Project	IEEE 802.16 Broadband Wireless Access Working Group < http://ieee802.org/16 >
Title	STP Enhancements for optional FUSC and AMC zones for OFDMA PHY Layer
Date Submitted	2004-05-07
Source(s)	<p>Wonil Roh, Panyuh Joo, Jaeho Jeon wonil.roh@samsung.com panyuh@samsung.com</p> <p>Samsung Electronics Co., Ltd. jhjeon@samsung.com</p> <p>Dong Suwon P.O.Box 105 416, Maetan-3dong, Yeongtong-gu, Suwon-city, Gyeonggi-do, Korea 442-600</p>
Re:	Sponsor re-circulation Ballot
Abstract	STP enhancements for the optional AMC and FUSC with all subchannels for the downlink
Purpose	Adoption of proposed changes into P802.16e
Notice	This document has been prepared to assist IEEE 802.16. It is offered as a basis for discussion and is not binding on the contributing individual(s) or organization(s). The material in this document is subject to change in form and content after further study. The contributor(s) reserve(s) the right to add, amend or withdraw material contained herein.

8.4.8.3 STP using the optional FUSC and the optional adjacent-subcarrier permutation zones for DL

Figure vyy-1 Pilot allocation method #1

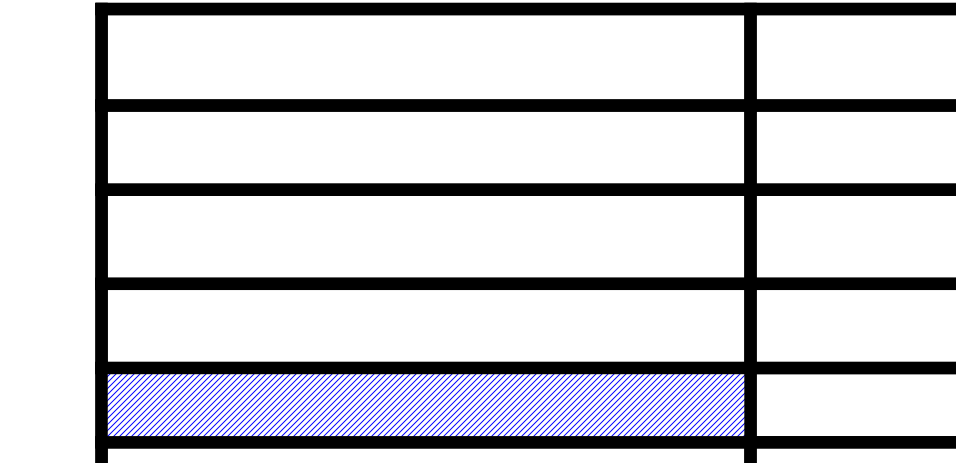
Method 1: use of disjoint pilot sets

Pilots are split into 2 or 4 disjoint sets. For 2-antenna BS, all pilots in the even symbols allocated for Ant 0 whereas all pilots in the odd symbols used for Ant 1. For 4-antenna BS, pilots in the even symbols are split for Ant 0 and 1, while those in the odd symbols split for Ant 2 and 3. See Figure yyy-1.

Figure vyy-2 Pilot allocation method #2

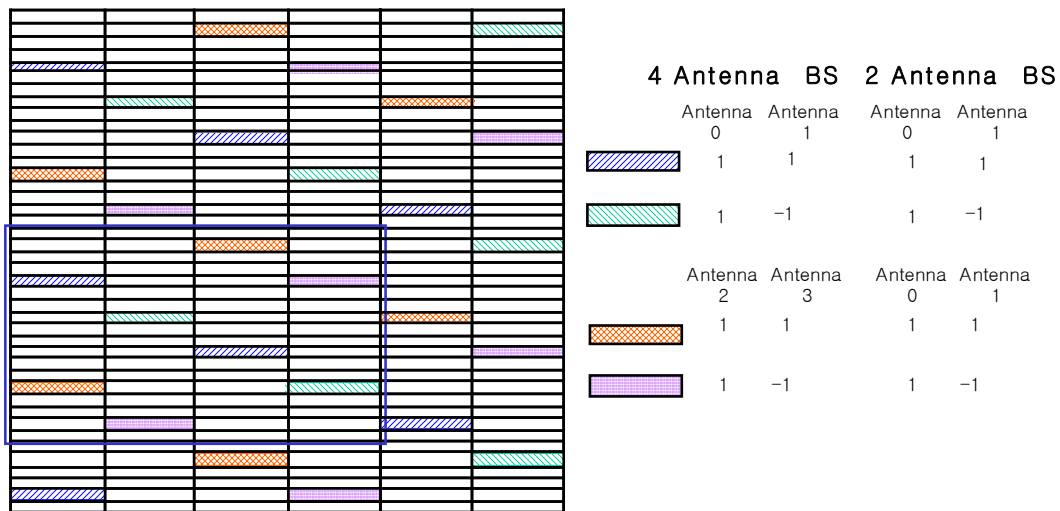
Method 2: use of orthogonal sequence on pilots

Pilots are shared with 2 or 4 antennas to increase the granularity and their orthogonality is maintained by the simple block code as shown in Figure yyy-2.
